Delegated Report

Planning Application No: 20250183
20250184

Location: 38 Windmill Street Gravesend Kent DA12 1BA

Description: 20250183 - Demolition of existing garages and creation of 6 parking spaces to the rear of 38 Windmill Street.

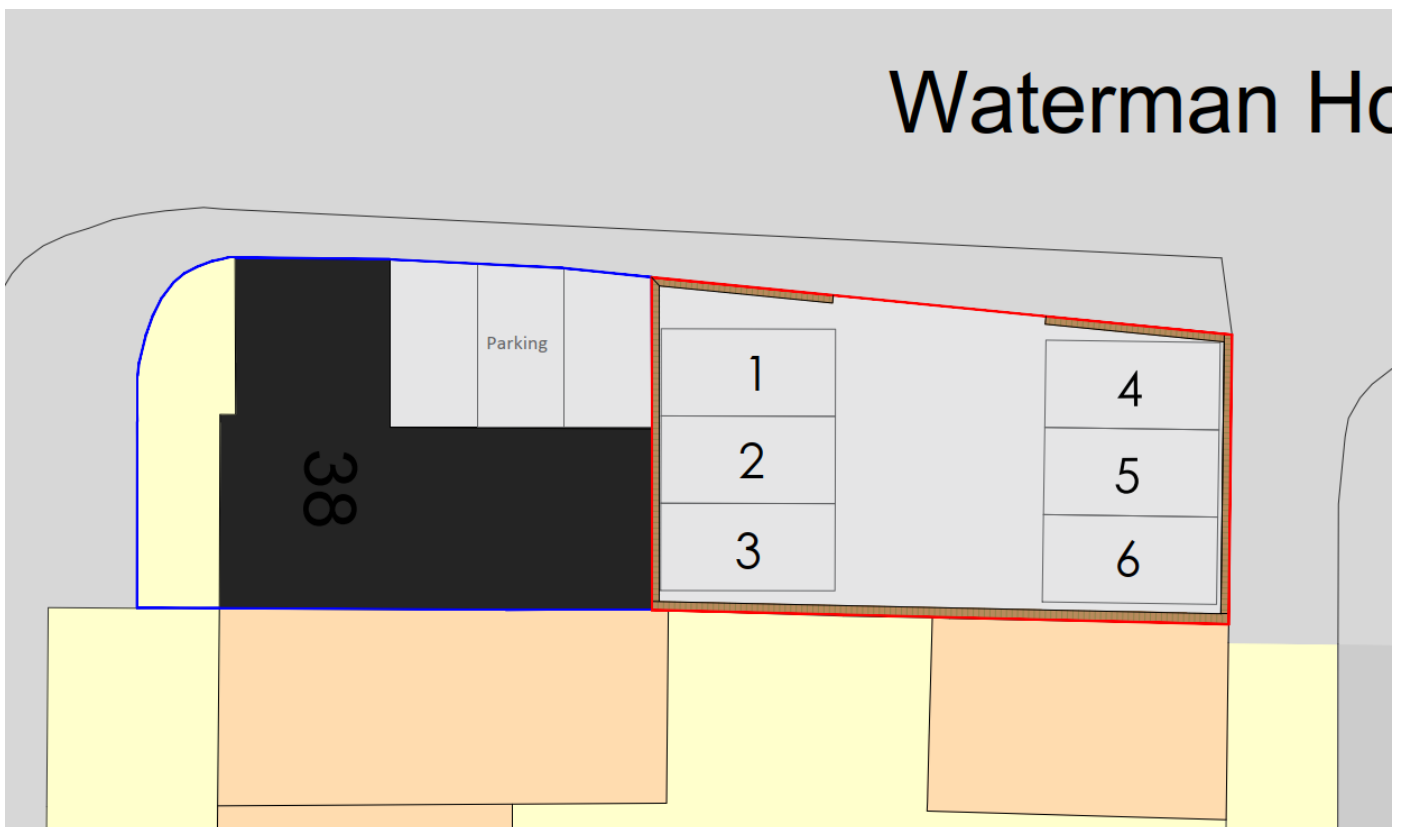
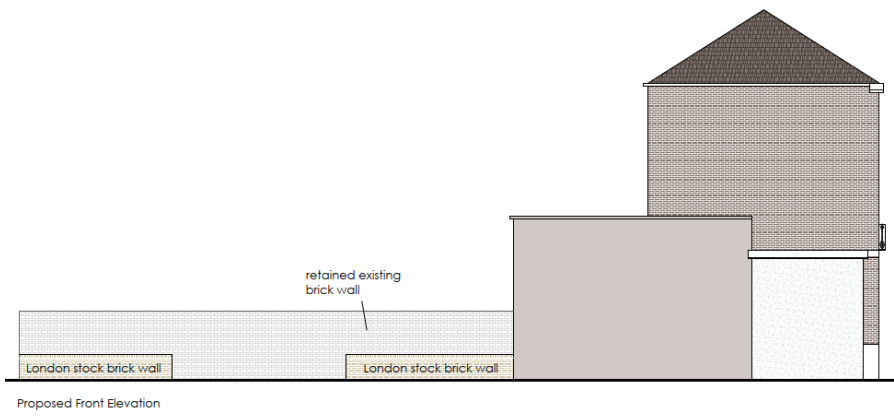
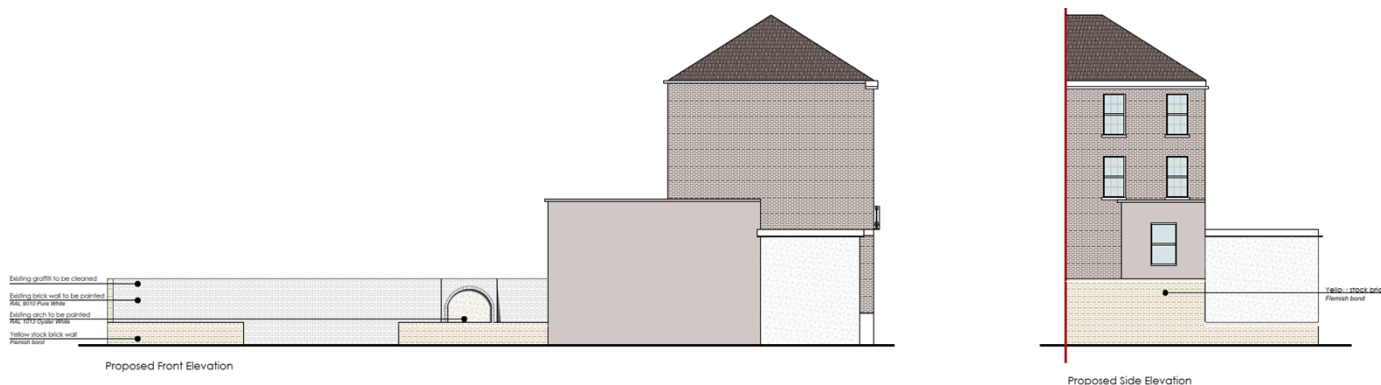
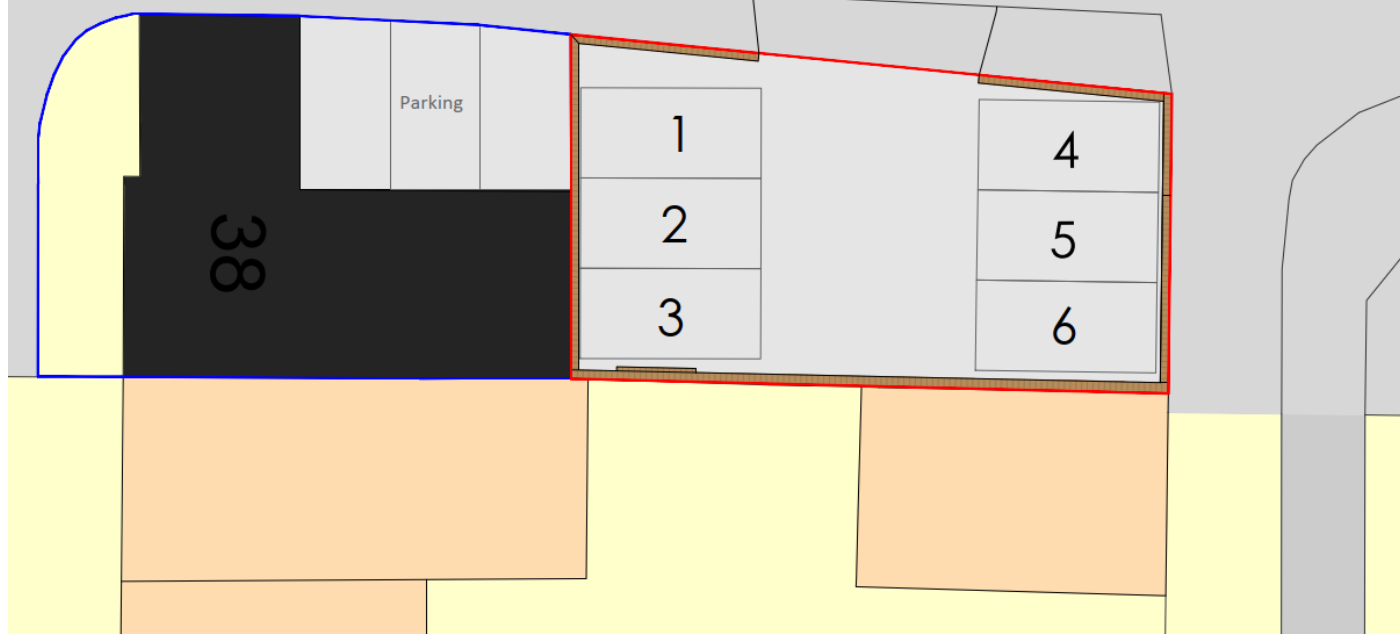
The drawings don't represent what is on site. When looking at Google Street View the existing back wall is partly yellow stock, forming the side wall of the adjacent stable building and a newer painted section has an arch in it that has been closed up with some timber stud work, possibly clad on the opposite side with weather boarding? There are a pair of black painted doors that appear to give access to the rear of Morris & Partners property, 39 Windmill Street. It's important that these elevations are properly surveyed and drawn as it will be very visible with the proposed removal of the garage structure that is already partially demolished. The back wall has a lot of graffiti on it and this will be very visible when the garage structure is removed. There is a high wall adjacent to the narrow road that services the rear of Windmill Street. Looking at Street View this appears to have been the original boundary wall built in yellow stock brick and raised in height when the garages were built (looking at the inside of the wall. Externally it has been rendered and pebble-dashed.

The proposal is to demolish everything back to the adjacent boundary wall and to build a low level wall in London Stock along two outer sides of the site – one low wall fronting onto the main road Lord Street/A226 and the other fronting onto the service road to the rear of Windmill Street.

The side wall fronting onto the service road should be retained as a high wall, as it is now, and stepped down as it was before it was demolished - see Google Street View Nov 2022 . If it is to be rebuilt it should be constructed in yellow stock, preferable reclaimed bricks and in Flemish bond so that it blends with the adjacent stable building. The existing boundary wall to the adjacent property should be cleaned of the graffiti, this could be conditioned, and the remainder of the boundary wall to the adjacent property should be painted as existing, in a colour to be agreed. How is the arched section to be treated? It will be highly visible and needs to be properly bricked up and painted to match the wall, preferably a sandstone colour. Samples of the brick for the low front wall need to be agreed, ideally these should be reclaimed bricks to match the high side wall.

In principle I have no objection to this application since, despite Lord Street being extremely busy, the dropped kerb to the existing garages and the proposed parking spaces already exists. However, no plan appears to have been submitted showing the size of the parking bays (which should be 5.0m x 2.5m) and the width of the aisle (which should be a minimum of 6.0m.). Also the width of the existing dropped kerb should be reduced to match the proposed new access. I would therefore raise no objection to this application provided the above information has been satisfactorily submitted.

The proposal as originally submitted showed the demolition of everything on the site back to the adjacent boundary wall and building of low level walls fronting Lord Street and the service road to the east. The Conservation Officer advised that the side wall fronting onto the service road should be retained or if to be rebuilt, should be retained to the same height wall and not the low height wall proposed. Also, that the wall that previously existed adjacent to it (a low wall as seen in the November 2022 Google Streetview image) should be rebuilt. The Conservation Officer advised that the entire high and low wall should be rebuilt in yellow stock brick (preferably reclaimed bricks) in a Flemish bond. The Conservation Officer also advised that the existing boundary wall to the adjacent property should be cleaned of graffiti and the remainder of the boundary wall to the adjacent property should be painted as existing. The Conservation Officer queried how the arched section in the wall was to be treated as it will be highly visible and needs to be properly bricked up and painted to match the wall, preferably in a sandstone colour. They advised that samples of the brick for the low front wall need to be agreed and that ideally these should be reclaimed bricks to match the high side wall too.

- Details of materials to infill the arched opening in the boundary wall
- Brick samples for all new walls
- Paint colour to be RAL 1013 Oyster white for all sections of wall to be painted.
- Parking area to be block paved and sample materials to be submitted.

Further to my previous consultation response dated 22nd April 2025, I have no objection to this proposal provided, as I previously mentioned, that the parking bay sizes are a minimum of 5.0m x 2.5m and that the aisle width is a minimum of 6.0m.

The agent was advised of the Conservation Officer's comments and revised plans have been received. These show that the side wall fronting onto the service road would be rebuilt and retained as a high wall as it is now and that the low wall which was previously demolished but as seen in the November 2022 Google Streetview image would be rebuilt; the wall fronting Lord Street would be built to the same height as this. All walls will be in a yellow stock brick in a Flemish bond. It is annotated that the existing graffiti is to be removed and the existing painted wall will be re-painted and the existing arch in the wall to be infilled will be re-painted.

The Conservation Officer was re-consulted on the revised plans and they have advised they are acceptable subject to conditioning details of materials to infill the arched opening in the boundary wall, brick samples for all new walls, paint colour for the walls to be RAL 1013 Oyster White and the parking area is to be block paved and sample materials to be submitted. As such, subject to conditions regarding brick and paint colours it is considered the proposal would protect the setting of the grade II listed no. 38 Windmill Street and would preserve the character and appearance of the Upper Windmill Street Conservation Area. As such in respect of heritage matters the proposal would be compliant with Policies CS19 & CS20 (LPCS) and saved Policies TC2 & TCS (LPFR).
